Re: Request for Amendment to the Tidewater Master Plan and Tidewater Village Design Guidelines

<p>Drawing:</p> <p>PARKING GARAGE EXTERIOR ELEVATIONS</p>	<p>Date: 05/23/08</p> <p>Scale: AS NOTED</p>	<p>Project:</p> <p>TIDEWATER VILLAGE TV2 DEVELOPMENT PARCEL</p>	<p>Architect:</p> <p>ARCHETYPE, P.A. ARCHITECTS 48 Union Wharf Portland, Maine 04101 (207) 772-6022 Fax (207) 772-4056</p>	<p>G-1</p>
---	--	---	--	-------------------

**Subject: TV2 – Amended Site Plan with Accessory Garage Buildings
Falmouth, Maine**

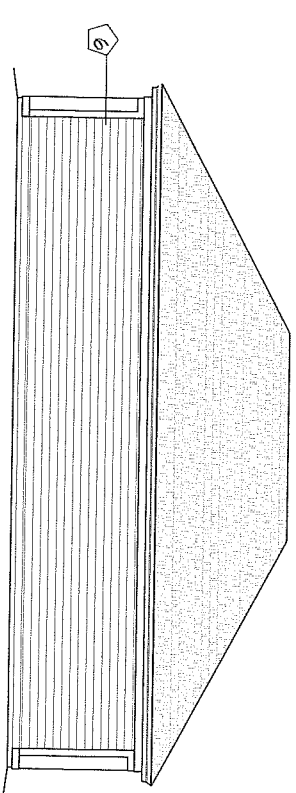
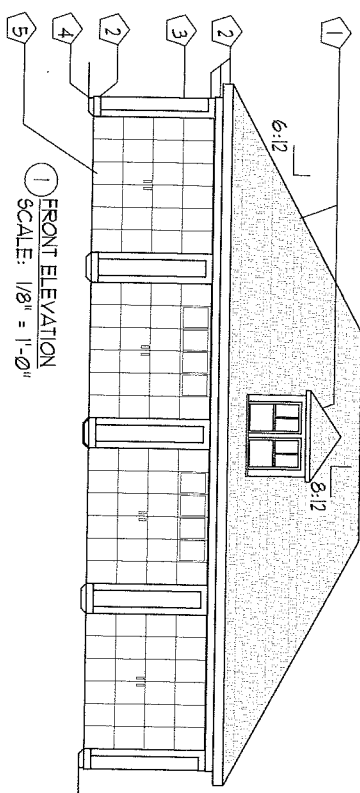
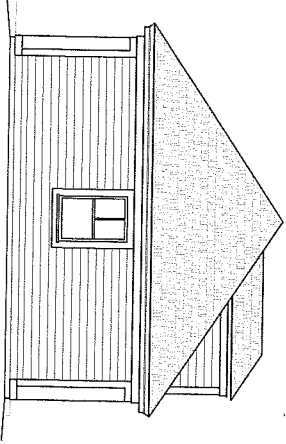
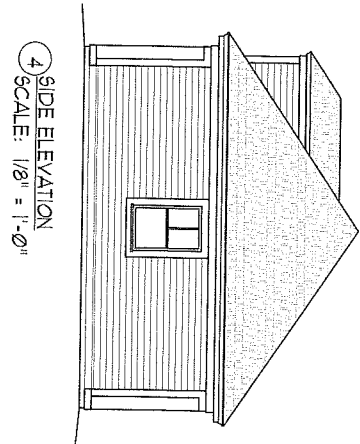
We believe that this issue must be addressed if this project is to ultimately succeed. A design has been developed to accommodate eight vehicles in the two accessory buildings (garages) which would be substantially located in areas which are approved as open surface parking. The two structures have been designed to meet the Tidewater Village design guidelines and are proposed to be located behind the main building directly across from the residential entry.

- **Maximum combined building footprint is 7500s.f.**/Impact - the proposed garages are accessory structures and are technically buildings which would add 2124.8s.f. of building footprint as follows;
